ADDENDUM NO. 2

GRANGER-HUNTER IMPROVEMENT DISTRICT, UTAH ANDERSON WATER TREATMENT PLANT PROJECT

November 20, 2024

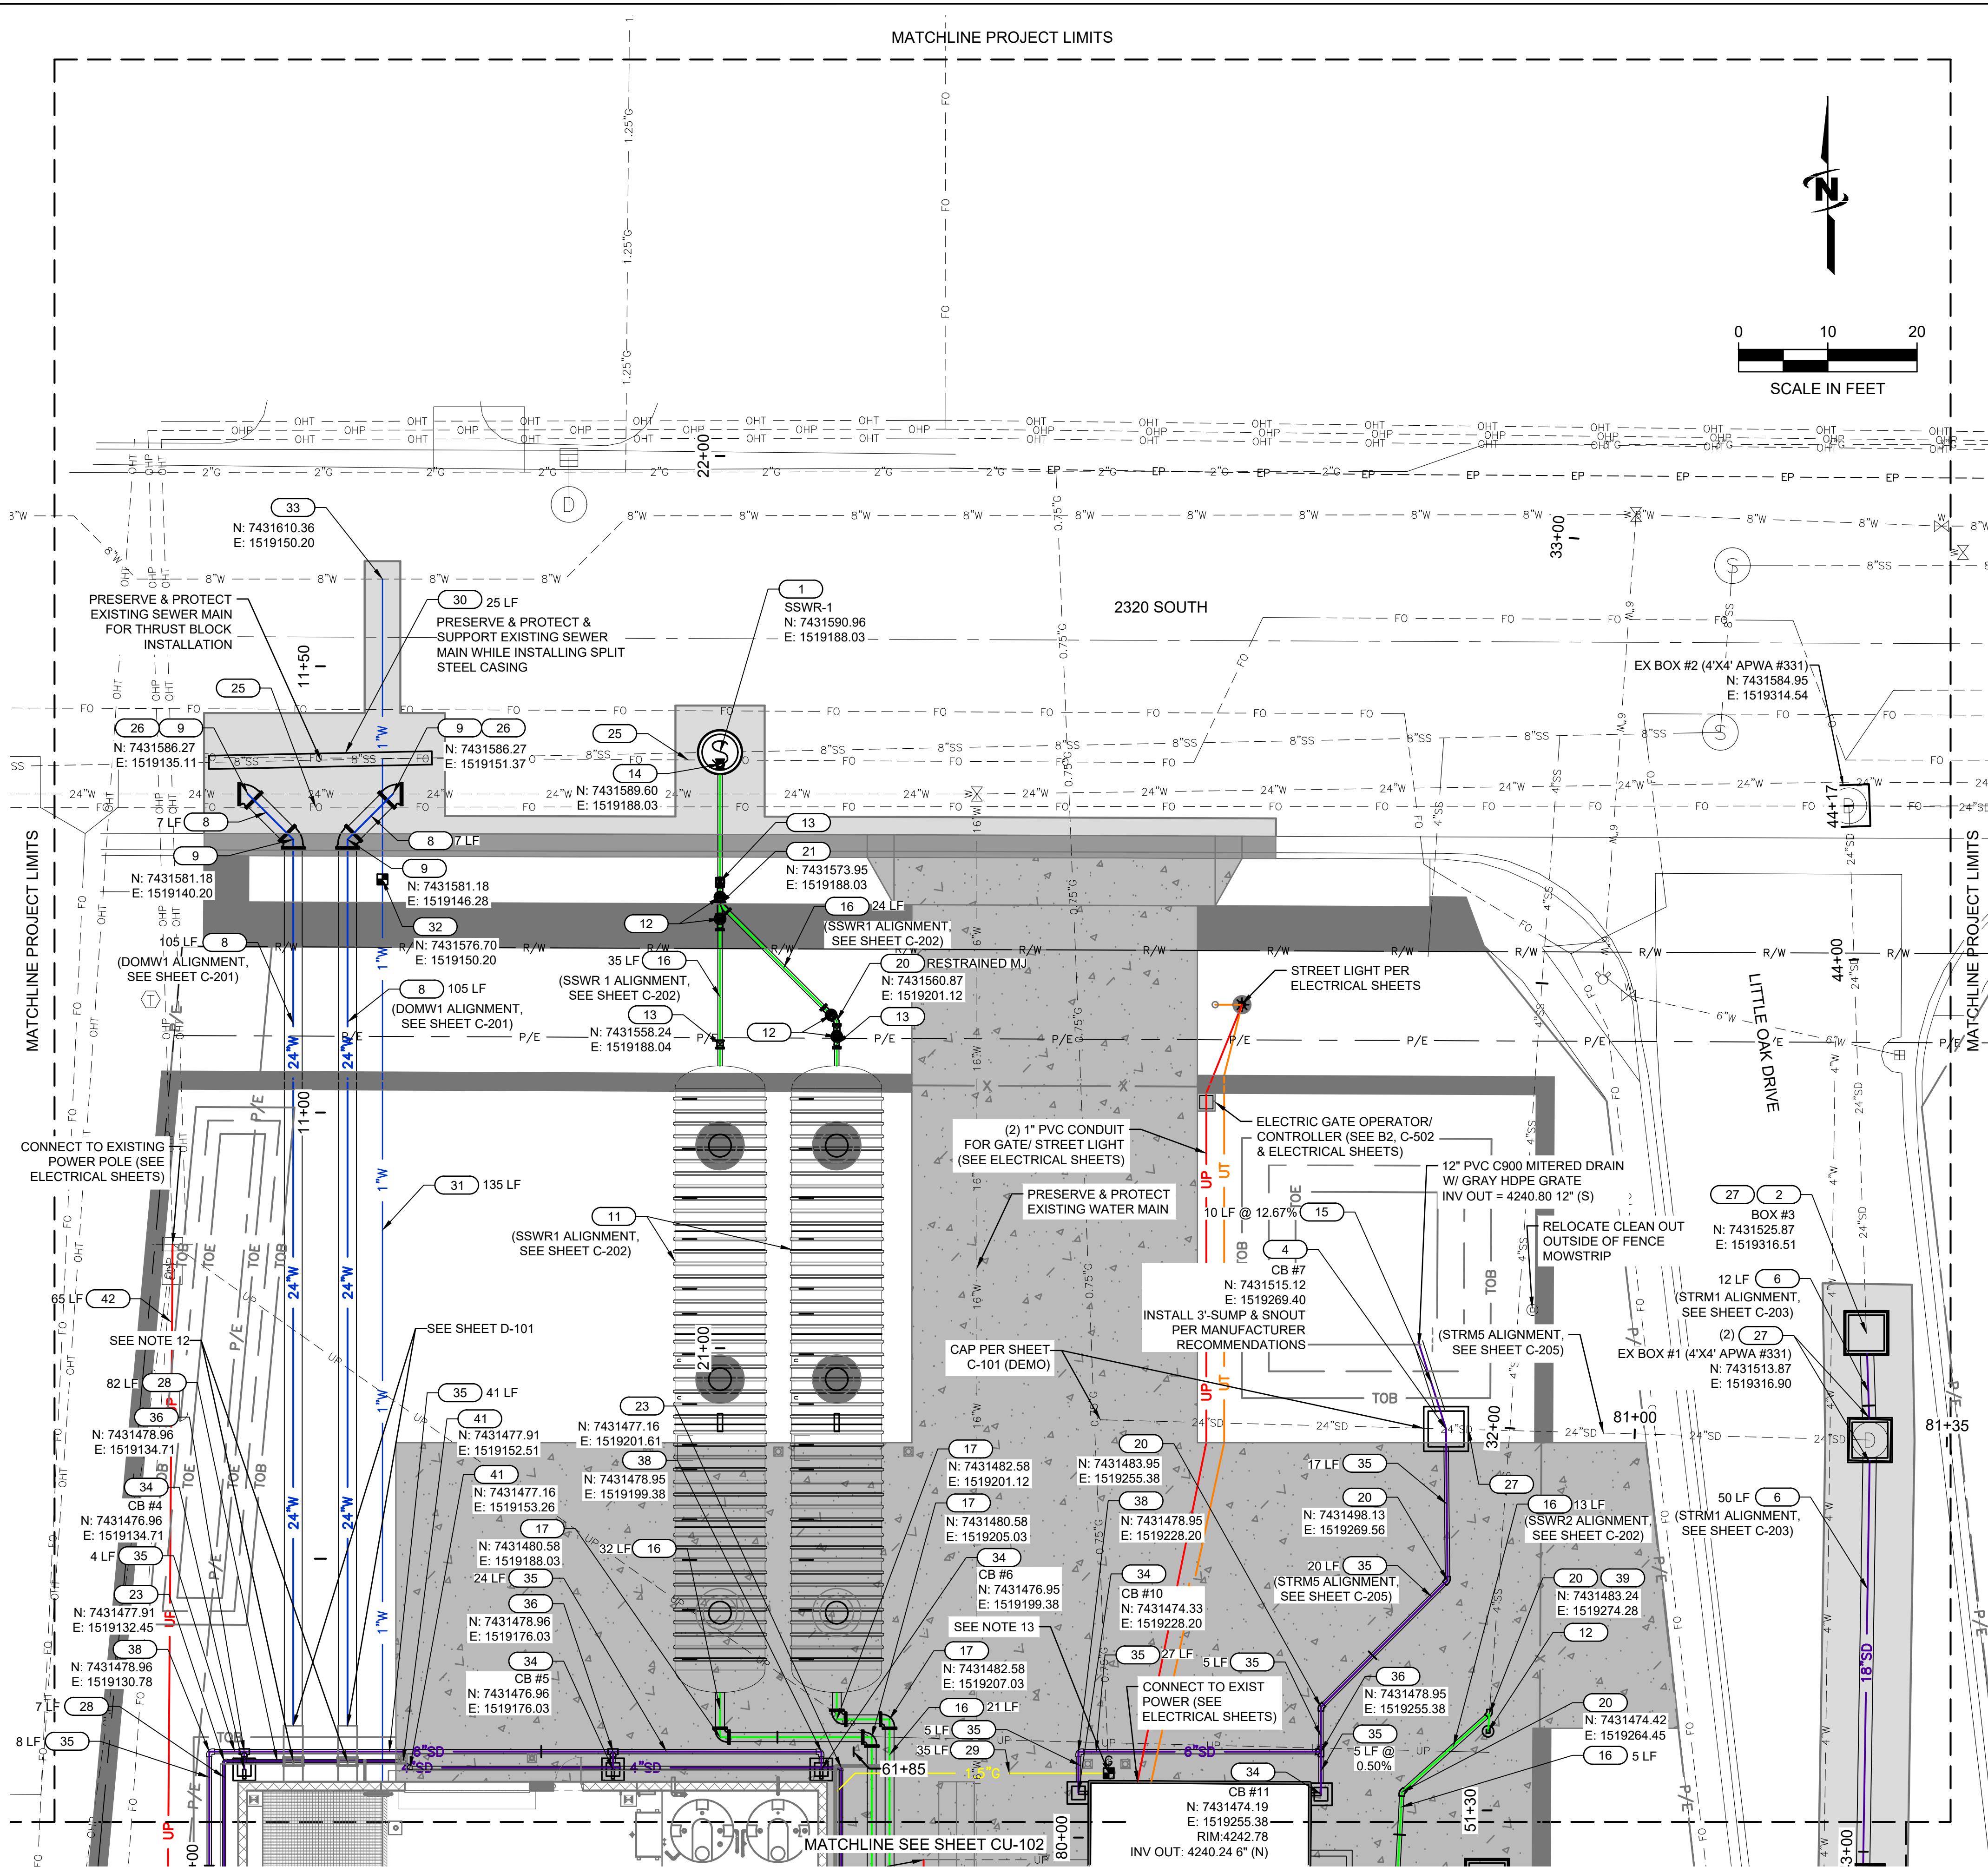
11. Has WesTech submitted the shop drawings? Has J-U-B completed review of the shop drawings?

J-U-B is currently reviewing the second submittal from WesTech. All submittals and responses to date have been included in Volume IV.

FILE: 93-23-004 CU-101X UTIL
JUB PROJ. #: 93-23-004
DRAWN BY: JTB
DESIGN BY: CAS / JPB
CHECKED BY: CLO
AT FULL SIZE, IF NOT ONE INCH, SCALE ACCORDINGLY
LAST UPDATED: 11/19/2024
DRAWING:
CU-101

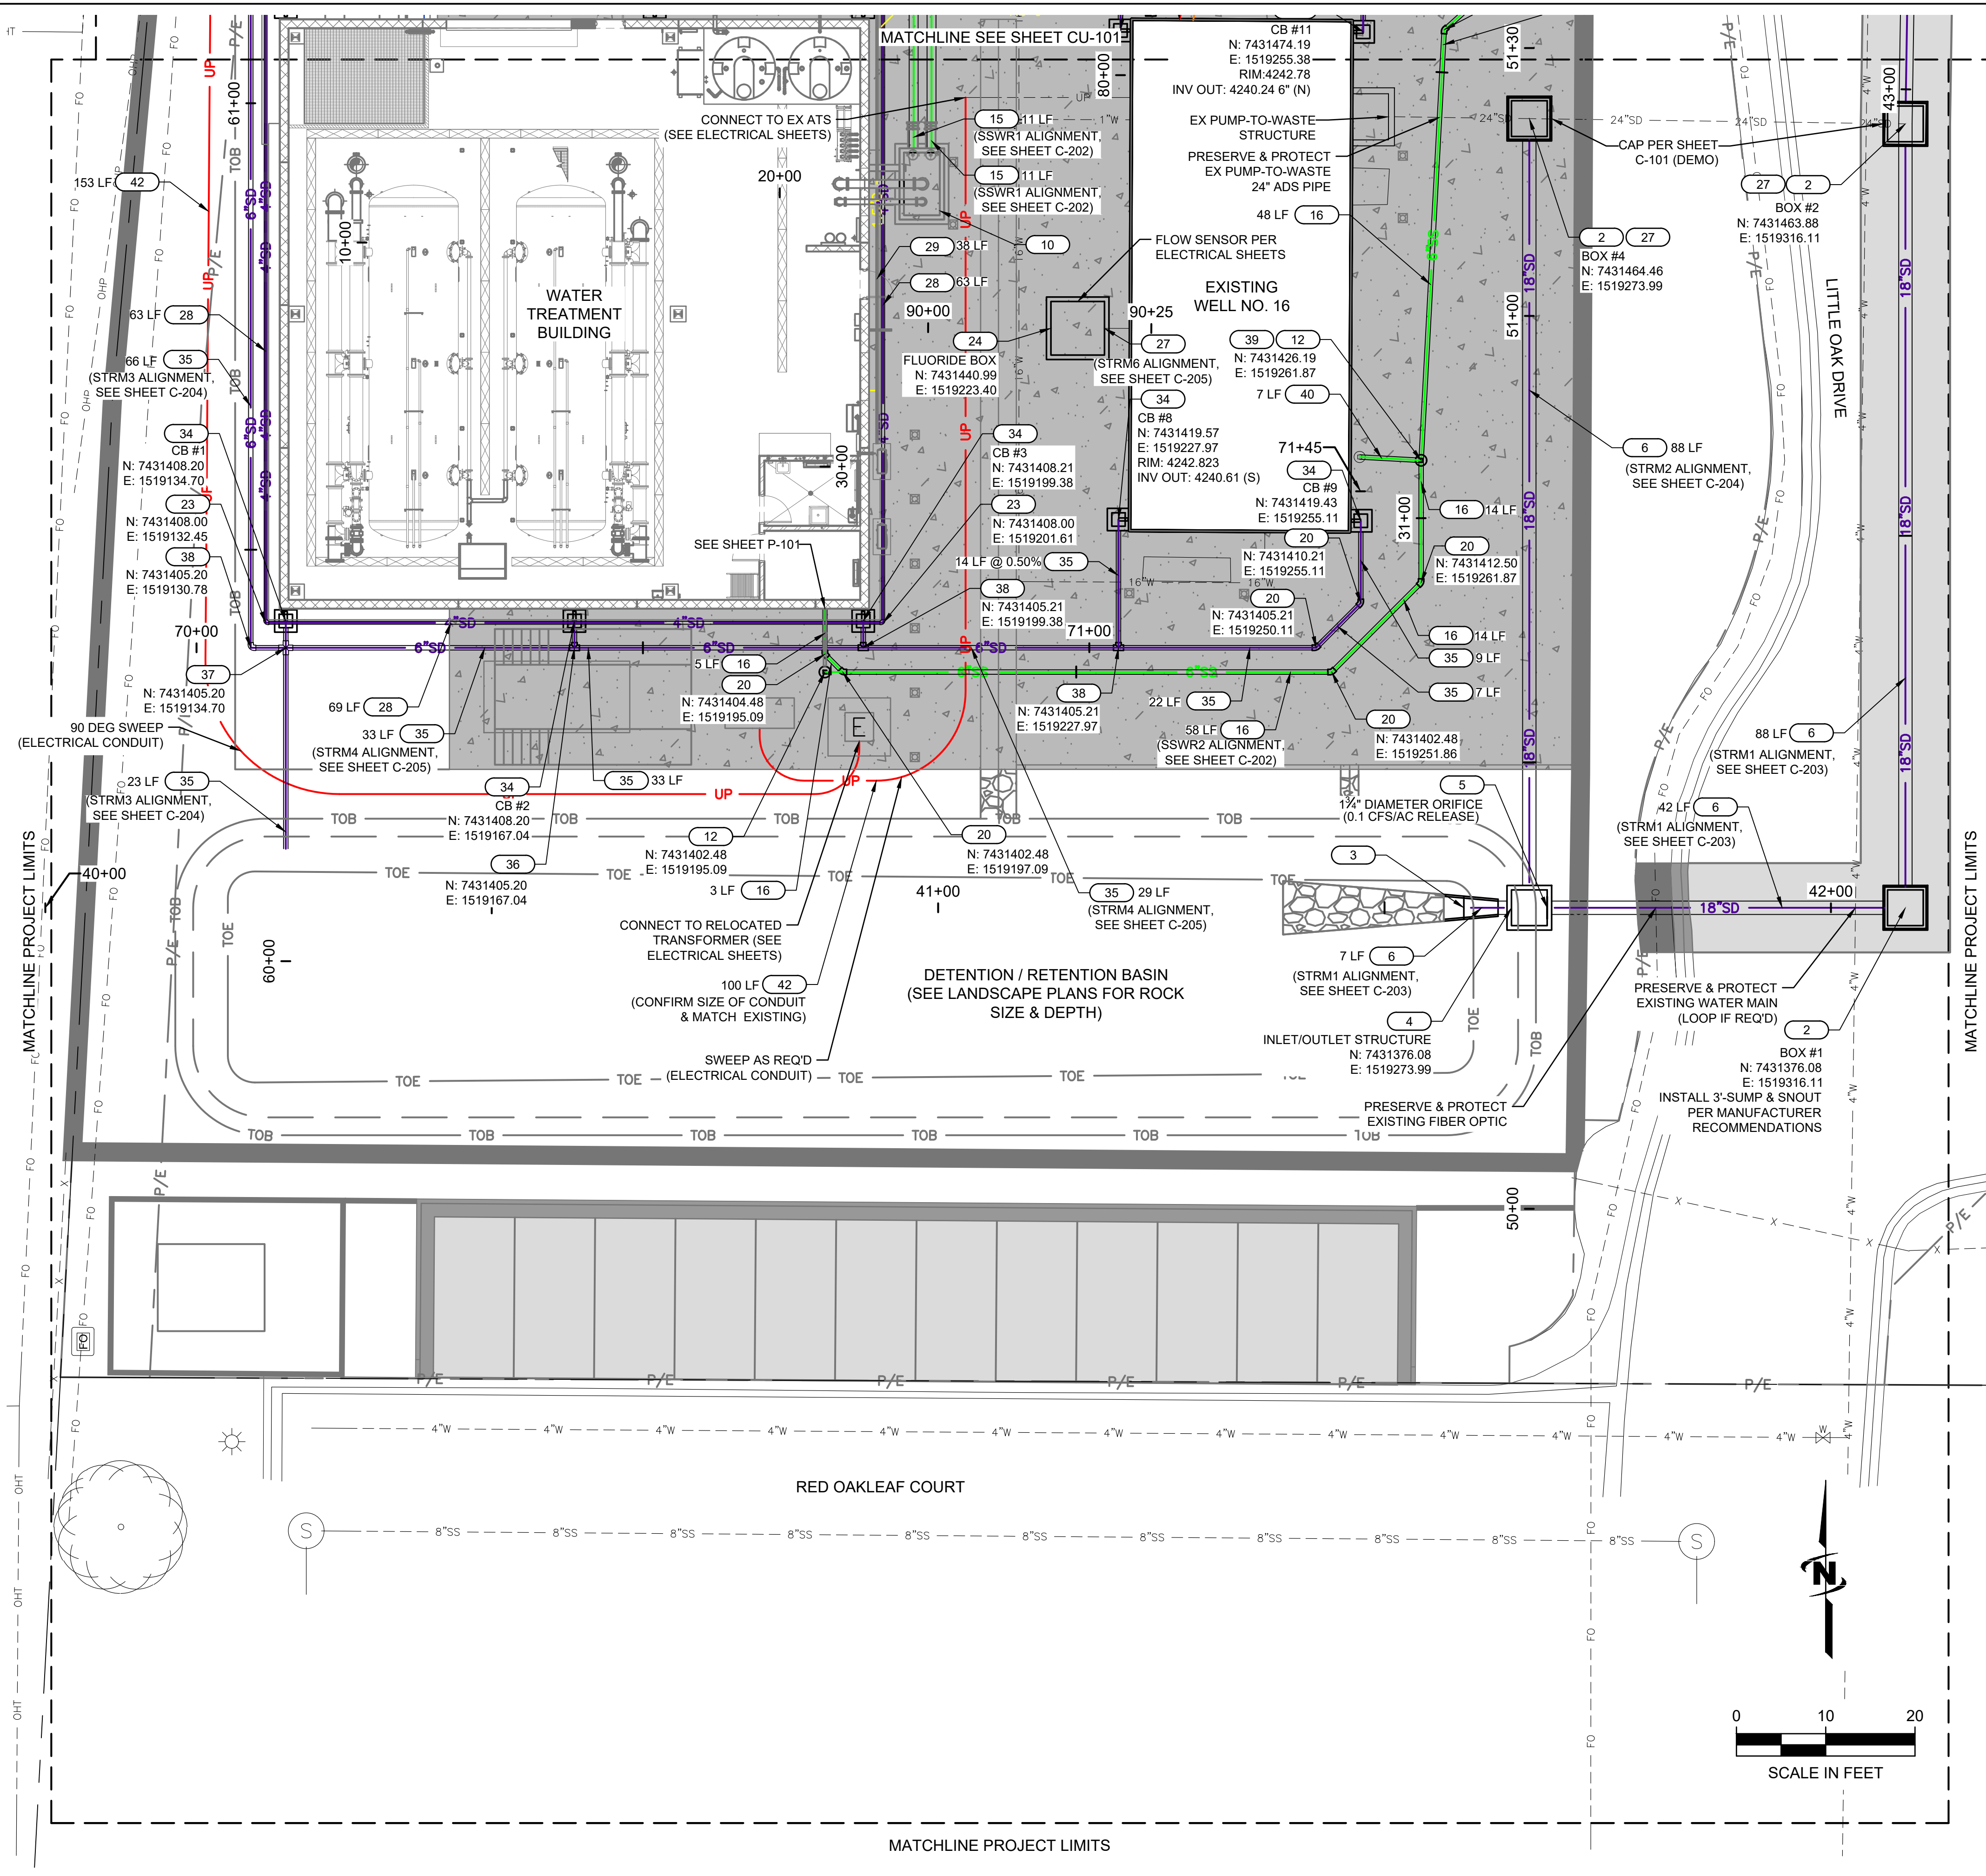
1. Sheet CU-101 and CU-102: Box #1, Box #2, Box #3 and Box #4, which are currently called out as keynote #2 as follows "48-IN X 48-IN STORM CLEANOUT BOX PER APWA STD PLAN 331.2 TYPE B W/ 30" TYPE A FRAME & COVER PER APWA STD PLAN 302.1", shall be updated to: "48-IN X 48-IN STORM CLEANOUT BOX PER **WVC STD DWG NO. 331** W/ 30" TYPE A FRAME & COVER PER APWA STD PLAN 302.1".
2. Sheet S-103: The S-103 roof plan notes call out 23'-10" which needs to be revised to 18'-0".
3. Sheets E-002 and E-104: Sheet E-002 Panel H shows (3) 480V 10kW heaters H-14 through H-30. Sheet E-104 also shows those heaters fed from H-14 through H-30. Instead, those heaters are gas heaters with internal disconnects and will need 120V power fed from Panel L, with 20A single pole breakers - one for each heater. L-36 through L-40 are available for those three heater fans.

- # CIVIL UTILITY KEYED NOTES:**
- 60-IN DIAM. DOGHOUSE SEWER MANHOLE W/ COLLAR PER DETAIL D1, C-503.
 - 48-IN X 48-IN STORM CLEANOUT BOX PER WVC STD DWG NO 331 W/ 30" TYPE A FRAME & COVER PER APWA STD PLAN 302.1.
